Docket Item # 7
BAR CASE # 2010-0063

BAR Meeting
April 21, 2010

ISSUE: Signage and Awning Replacement
APPLICANT: Bittersweet (Robert Blumel, Agent)
LOCATION: 821 King Street
ZONE: KR / King Street Retail Zone

Figure 2. Alfred Street Elevation Proposed

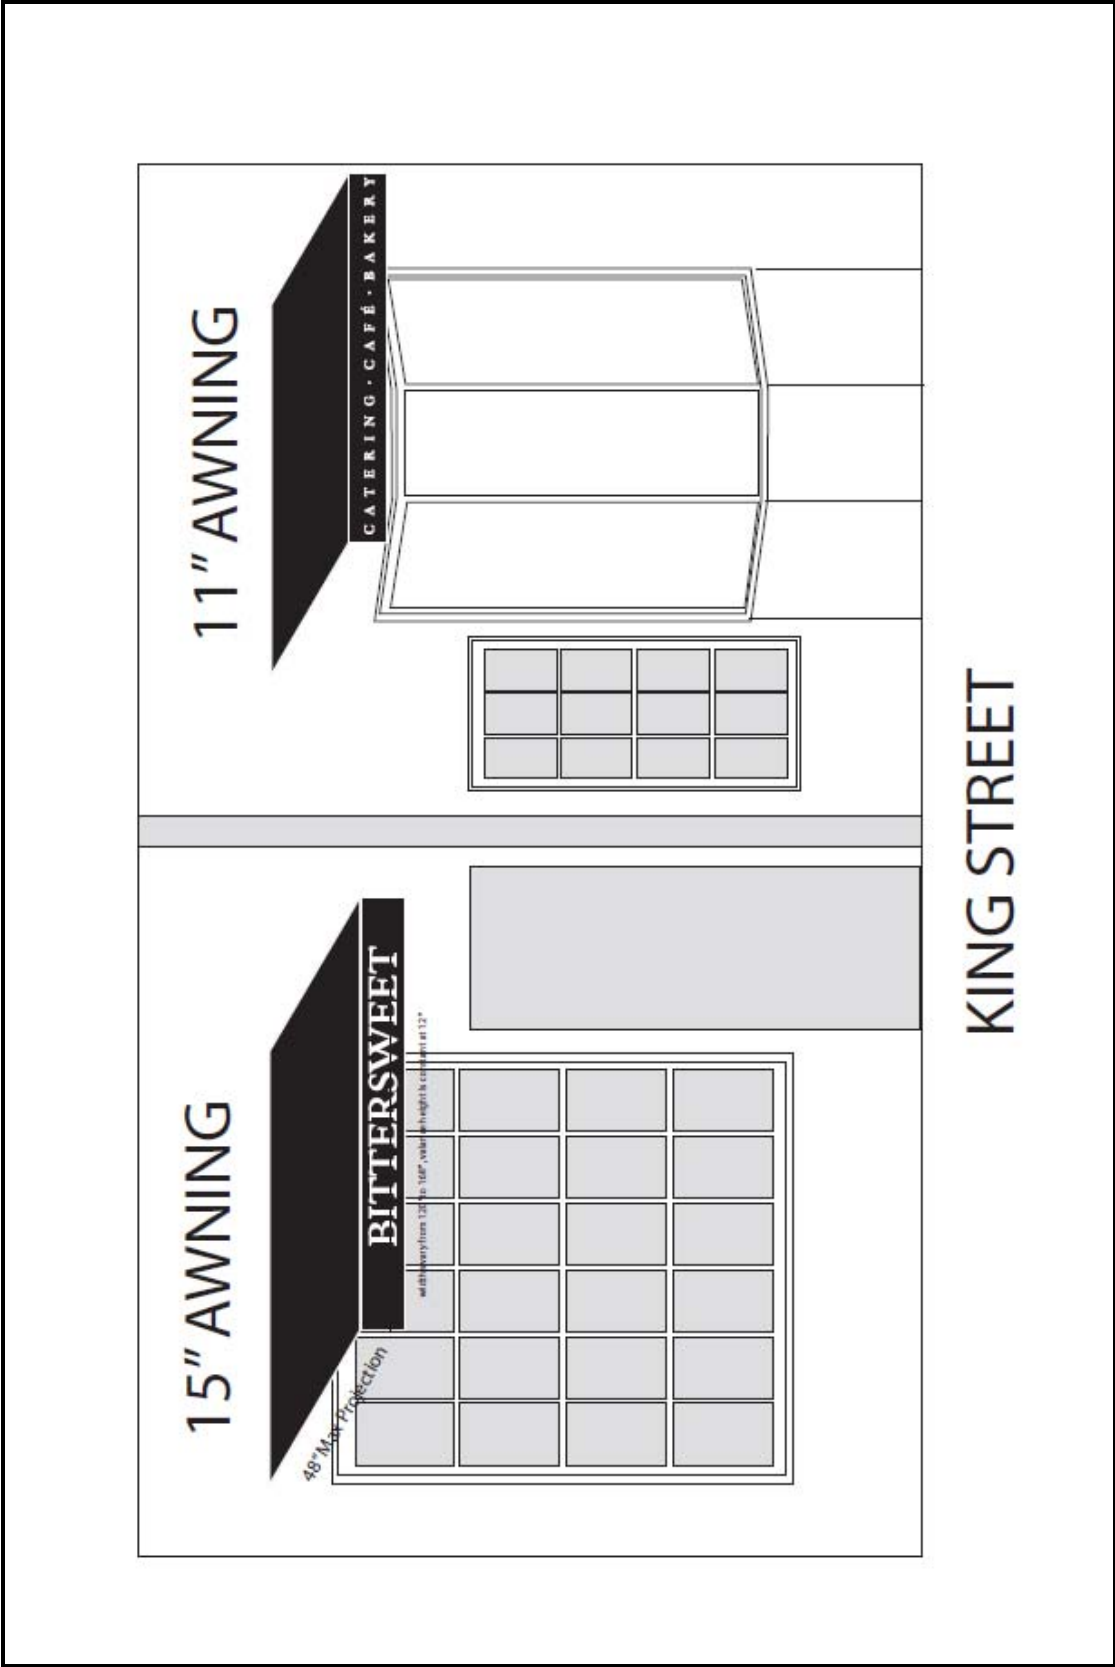
The applicant is requesting approval of a Certificate of Appropriateness to remove the seven (7) existing, stationary shed-style awnings with seven (7) new, shed-style, retractable awnings on the commercial building located at 821 King Street. The widths of the awnings vary from 10'-14' with a 12" valance. The operable awning will be fabricated of a steel, frame wrapped with Sunbrella fabric. The proposed color scheme for the awnings are a black background, with white lettering identifying the restaurant's name "Bittersweet" and the restaurant type "Catering * Café * Bakery".

The applicant proposes to mount the awning above the existing, first floor fenestration, 8' above-grade, as measured from the bottom of the awning to sidewalk.

The proposed awning's widths vary from 10'-14' with a 12" valance and are fabricated of a metal frame sheathed with Sunbrella fabric. These specifications meet the requirements outlined in the *Design Guidelines* for size, design, mounting specifications and materials. Additionally, the proposed awnings do not detract from the current style of the building and are similar to retractable Board approved awnings installed on other establishments within the historic district (see photo below of retractable awnings approved at 1025 King Street, Catholic Book Store.)

The applicant is proposing to mount the awning to the building by utilizing bolts installed into the masonry's mortar joints.

- F-1 The applicant shall obtain a sign permit and building permit for the proposed sign and/ or wall lettering.
- C-1 Awnings must comply with all applicable requirements of USBC 3105.3 and 3202.3.1 Retractable and fixed awnings must have a minimum 7 foot clearance from a sidewalk to the lowest part of the framework or any fixed portion of any retractable awning is required. Retractable awnings must be securely fastened to the building and can not extend closer than 24 inches in from the curb line (USBC 3202.3.1).
- C-2 Fixed awnings must be designed and constructed to withstand wind or other lateral loads and live loads required by the USBC. Structural members must be protected to prevent deterioration (USBC 3105.3).

Staff recommends approval of the Certificate of Appropriateness as submitted.
